Office Action Summary

10/810,452

SUTARDJA, SEHAT

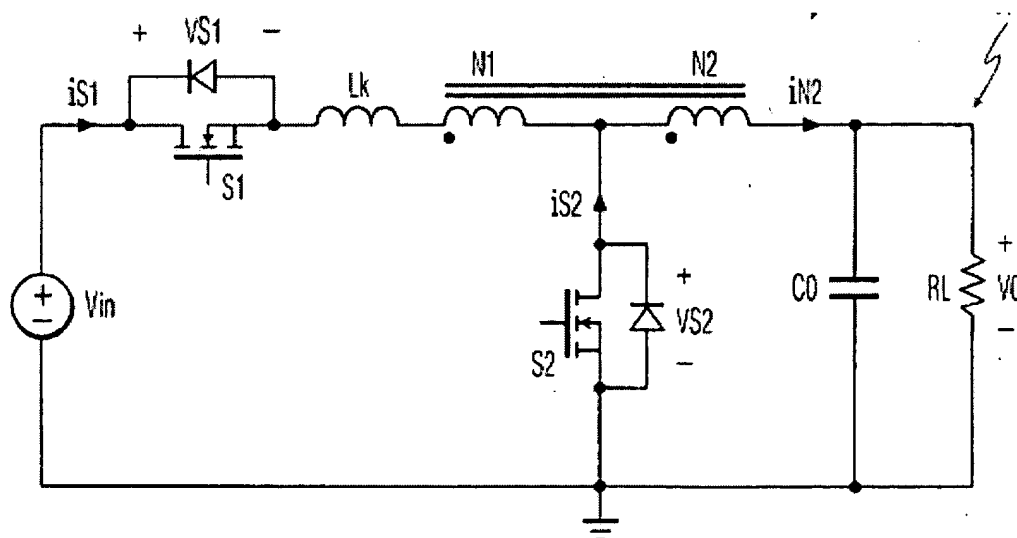
(USP 5,636,107). Qian discloses the claimed invention a coupled inductor with first, N1, and second, N2, windings connected in series to form a common node, a conduction switch, S1, and a freewheeling switch, S2, the inductor is formed on a single core, and an output capacitor, Co. See figure below.

Qian discloses the claimed invention except for turns ratios of the inductor devices. Lu discloses that it is known in the art to provide the turns ratios of the inductor devices of having a relationship of the $N1/N2$ windings of the transformer to be 2. The turns ratio indicates the amount by which the transformer increases or decreases the voltage applied to the primary. For example, if the secondary of a transformer has two times as many turns as the primary, the voltage induced into the secondary will be two times the voltage across the primary. (As is with the case of applicant's claimed invention). If the secondary has one-half as many turns as the primary, the voltage across the secondary will be one-half the voltage across the primary. However, the turns ratio and the current ratio of a transformer have an inverse relationship. Thus, a 1:2 step-up transformer will have one-half the current in the secondary as in the primary. A 2:1 step-down transformer will have twice the current in the secondary as in the primary. (As is with the case of applicant's claimed invention).

It would have been obvious to one having ordinary skill in the art at the time of the invention was made to provide the turns ratios of the inductor devices of having a relationship of the $N1/N2$ windings of the transformer to be 2 of Lu with the controlled inductive switching circuit of Qian, in order to provide a simplistic approach to control the output voltage and output current induced in the secondary by changing the turns ratio of the transformer.
